Access Compliance Report

Public Rights-of-Way

(Curb Ramps)

Intersection ID: 43671	Main Street: ARMOUR RIDGE DR	Cross Street: ASHETON CREEK DR	Location: E
ADA ID: E1DE71B2EAA1	Ramp Type: Perp	Initial Pass/Fail: Fail	Overall Compliance: No
Severity Score: 26.25			
Codes/Mitigation Info/Possible Solution		Field Measurements/Component Compliance

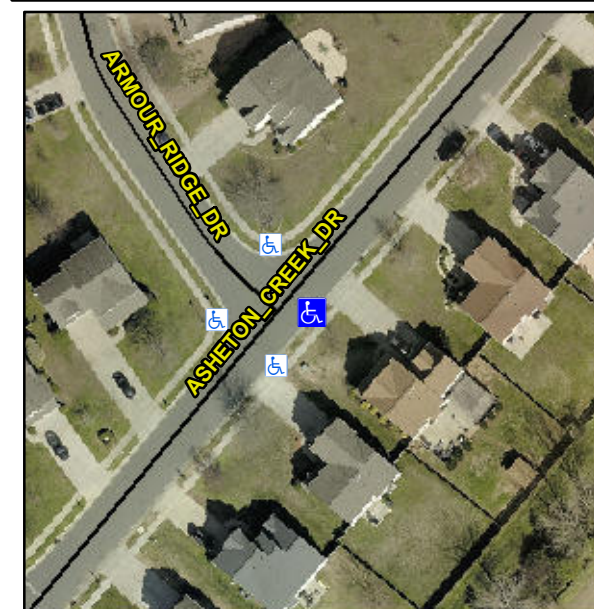
R304.2.2, R304.5.3

Compliance	Description	Data	Compliance	Description	Data
N/A	Ramp Length (in)	46.0	No	Ramp Slope (%)	14.7
Yes	Ramp Width (in)	48.0	No	Ramp XSlope (%)	4.1
N/A	Flare Type LT	N/A	N/A	Flare Type RT	N/A
N/A	Flare Slope LT (%)	N/A	N/A	Flare Slope RT (%)	N/A
N/A	Flare Traversable LT?	N/A	N/A	Flare Traversable RT?	N/A
N/A	Landing Length (in)	N/A	N/A	DWS Provided?	N/A
N/A	Landing Width (in)	N/A	N/A	DWS Contrast?	N/A
N/A	Landing Slope (%)	N/A	N/A	DWS Length (in)	N/A
N/A	Landing X Slope (%)	N/A	N/A	DWS Full Width?	N/A
N/A	Landing Curb? (Y/N)	N/A	N/A	DWS Offset (in)	N/A
N/A	Shared Landing?	N/A			
N/A	Gutter Ponding?	N/A	N/A	Gutter Slope (%)	N/A
N/A	Gutter Lip Ht (in)	N/A	N/A	Gutter X Slope (%)	N/A
N/A	Painted X Walk1?	No	N/A	Painted X Walk2?	N/A
	X Walk 1 Direction	To NW		X Walk 2 Direction	N/A
N/A	X Walk 1 Width (in)	N/A	N/A	X Walk 2 Width (in)	N/A
	X Walk 1 Slope (%)	2.7		X Walk 2 Slope (%)	N/A
	X Walk 1 X Slope (%)	0.8		X Walk 2 X Slope (%)	N/A

Remove & Replace Entire Ramp.
